ADDENDUM NO. Two

Date of Addendum: 08/26/05

PROJECT NAME: Jesse H. Jones Central Library Renovation-
Carnegie Regional Branch Library Renovation-
Library Resource Center Renovation-

PROJECT NO: E-0011-01-3

Re: Roll-up fire doors

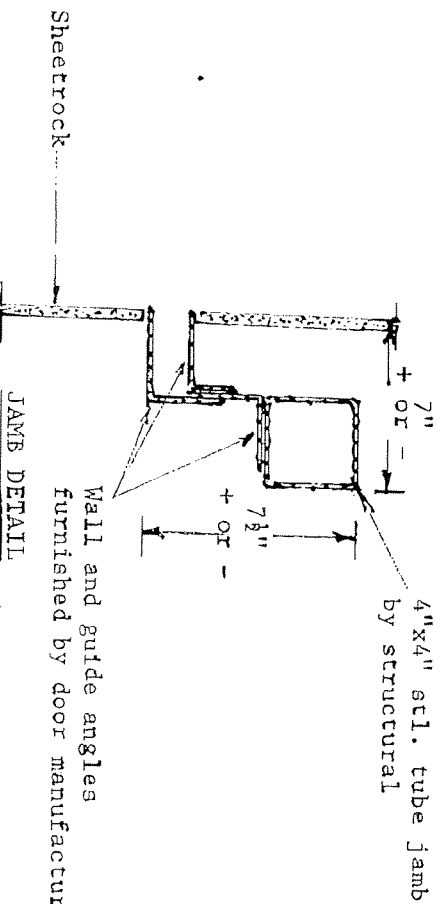
Jamb details #3, #4, #5, #6, #15 and #32 on Sheet A2.814 and #12 and #18 on Sheet A4.040 are for manually operated non-rated roll-up service doors, not for chain hoist operated fire doors. The detail shown below will be the actual detail. Walls will need to be redesigned to accommodate the thickness of the guide and tube jamb.

Jamb details #10 and #16 on Sheet A2.813 indicates "existing guides". These guides cannot be reused. The existing marble will have to be demoed to remove the guides and the same jamb detail shown below will be used.
